# Fairbridge Way, Burgess Hill – Pedestrian and Cycle Access

Stage 1/2 Road Safety Audit

Project number: 60610807  
60610807-ACM-HGN-FAIR-RP-SA-0001

**IMAGE:** Extract of Drawing 60610807-ACM-CS-FBW-DR-HW-0700 showing absence of onward route and pinch-point.

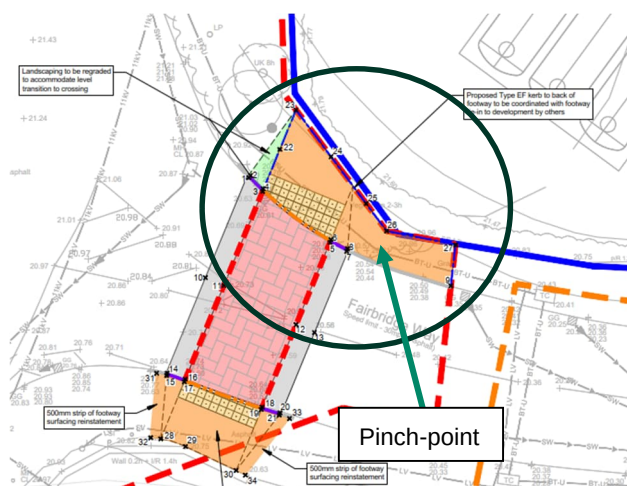
**Summary:** No details of onward connections provided, and short section of proposed cycle/ footway contains a pinch-point. Crossing users may become stranded and use inappropriate onward routes such as within the live carriageway where they could be struck by passing road users, or the pinch-point may result in collisions between cyclists and other cycle/ footway users.

It is understood that the proposed raised crossing will provide access to a new future development site on the northern side of Fairbridge Way, located to the east of Isaac's Lane and to the northeast of the roundabout. Although a very small area of shared cycle/ footway is proposed immediately to the east of the northern crossing waiting/ landing area, no clear details of any proposed onward connections for crossing users are provided in any direction from this point. If the crossing is provided without any suitable onward routes, then this may result in non-motorised users accessing the live carriageway at this point to continue their journey, increasing the risk of collisions between non-motorised users and vehicles.

In addition to the above, the short section of proposed shared cycle/ footway on the northern side of Fairbridge Way and to the east of the crossing has a pinch-point (circa 1.6m wide). As a result, some users of the shared cycle/ footway (e.g. wheelchair users, pushchair users or cyclists) may struggle to use the cycle/ footway, causing them to enter the live carriageway to bypass the pinch-point where they could be struck by passing road users. Additionally, the pinch-point could increase the risk of collisions between cyclists and other users of the shared cycle/ footway at this location.

It is recommended that suitable onward cycle/ footway provision, with suitable tie-ins, widths and alignments to address the concerns set out above, is provided in the final associated design.

**IMAGE:** Extract of Drawing 60610807-ACM-CS-FBW-DR-HW-0010 showing location of roundabout island and proposed crossing.

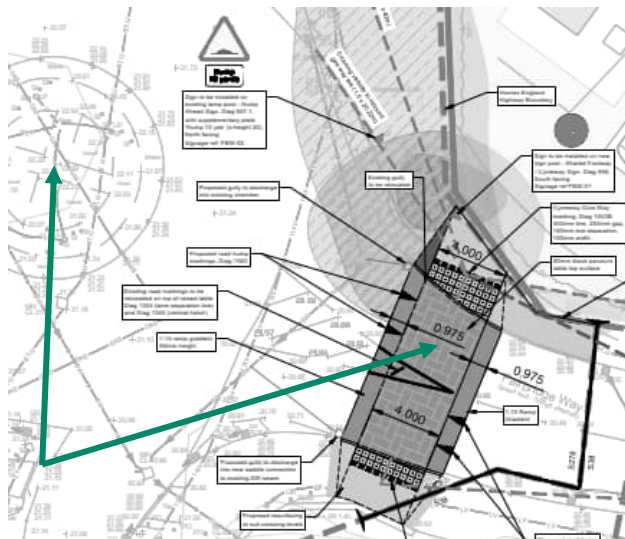
**Summary:** Roundabout central island and proposed crossing position/ layout may restrict visibility to the crossing for road users entering the roundabout from Cuckfield Road, resulting in vehicle collisions with crossing users and/ or rear end shunt type collisions on the circulatory carriageway.

The proposed raised crossing is located adjacent to the edge of the roundabout circulatory carriageway on Fairbridge Way (eastern arm). Road users joining the roundabout from Cuckfield Road (northwestern arm) and circulating the roundabout will have limited forward visibility to the crossing due to both the location of the crossing (close to the circulatory carriageway edge) and the size/ position of the roundabout central island. This may result in vehicle/ crossing user collisions on the crossing or rear end shunt collisions as road users suddenly brake as they approach the crossing on the roundabout exit.

It is recommended that the crossing location and/ or layout is revised. Potential options include providing a splitter/ refuge island halfway across the crossing or relocating the crossing further east on Fairbridge Way. Given the visibility concerns raised it is advised that additional pedestrian/ cycle warning signage is provided on the approaches to the crossing in any case. See also **Problem/ Recommendation C1**.

**IMAGE:** Extract of Drawing 60610807-ACM-CS-FBW-DR-HW-0200 showing 40m forward visibility splay and retention of tree.

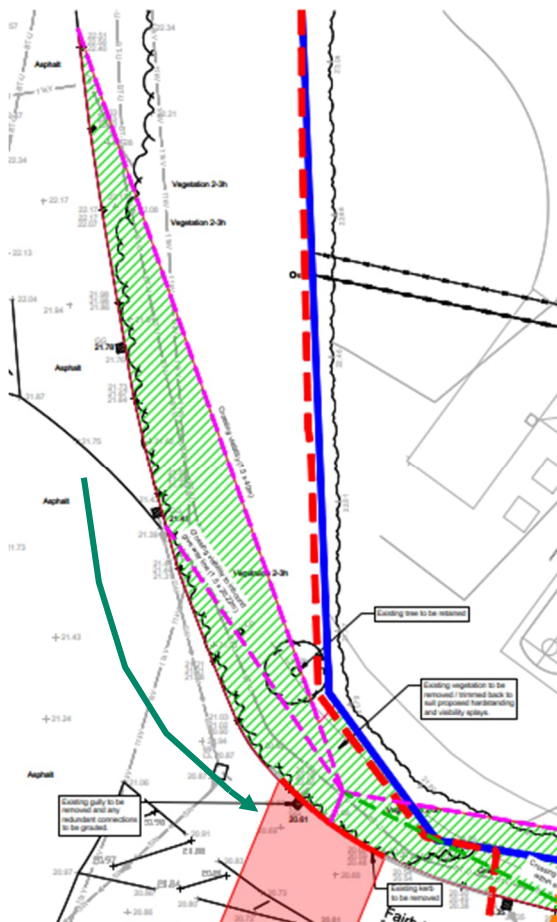
**Summary:** Restricted intervisibility between the northern part of the proposed crossing (including waiting area) and road users approaching roundabout from Isaac's Lane may result in vehicle collisions with crossing users and/ or rear end shunt type collisions on the circulatory carriageway.

Significant vegetation removal appears to be proposed on the eastern side of Isaac's Lane as part of the scheme. However, it is unclear whether sufficient intervisibility will be achievable between road users approaching the roundabout on Isaac's Lane and crossing users on the northern side of the proposed crossing on Fairbridge Way, due to the following reasons:

- Vehicle speeds on Isaac's Lane on the approach to the roundabout appear to be higher than the posted 30mph speed limit, perhaps due to the downhill gradient of the approach and the rural setting
- The drawings indicate that only 40m forward visibility will be provided between Isaac's Lane and the northern side of the crossing following the proposed vegetation removal
- The drawings indicate that a large tree will be retained within the intervisibility splay between Isaac's Lane and the northern side of the crossing.

Should there be insufficient intervisibility between road users approaching the roundabout on Isaac's Lane and users of the proposed crossing this may result in vehicle/ crossing user collisions on the crossing or alternatively rear end shunt type collisions as road users suddenly brake as they turn left into Fairbridge Way from Isaac's Lane.

**IMAGE:** Extract of Drawing 60610807-ACM-CS-FBW-DR-HW-0700 showing proposed crossing carpet.

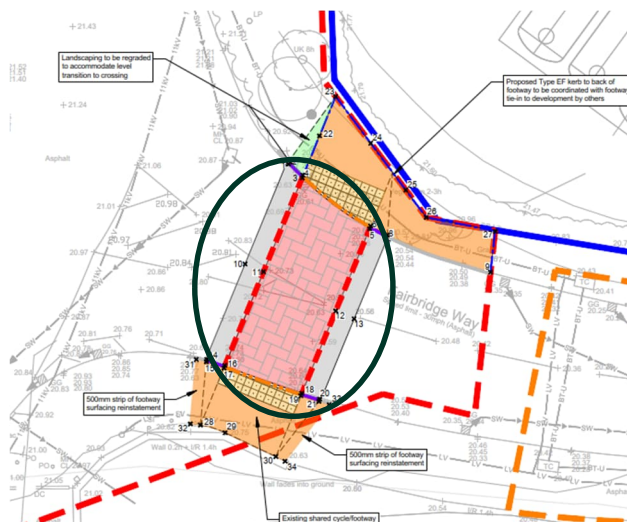
**Summary:** Crossing carpet may become slippery during wet or icy conditions, resulting in potential slips/ falls and subsequent personal injury or conflicts between road users and crossing users.

The proposed carpet of the raised crossing will be 4m in width, consisting of concrete block paviours laid in an offset herringbone pattern. The crossing appears to be on a flat gradient with ramps down to the carriageway on each side. It is unclear from the information provided whether the crossing carpet will drain adequately during wet conditions, or whether water could otherwise accumulate on the crossing causing a potential slip hazard to crossing users (particularly cyclists), with risk of subsequent slips/ falls and resultant personal injury and/ or vehicle collisions with crossing users. The crossing could also become icy during the winter months if water is not able to drain adequately, increasing the risk.

It is recommended that the proposed surfacing/ layout of the crossing carpet is reviewed and revised as necessary so that the crossing able to drain adequately and so any slip hazard is minimised, during wet or icy conditions.
